06-13 BLUE SUSHI - NASHVILLE, TN

Project Issue Information

MicrosoftTeams_image_5_.png

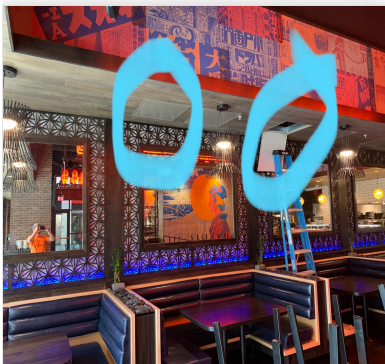
Issue Name : Missing and loose cleanout door

Description : There is one missing cleanout door located in the discharge duct run of the pcu. There is also a loose cleanout door see pictures for locations

- **06/05/2022** **National TAB - Will Turnbough**
 - Loose cleanout door and access panel locations to access both doors.
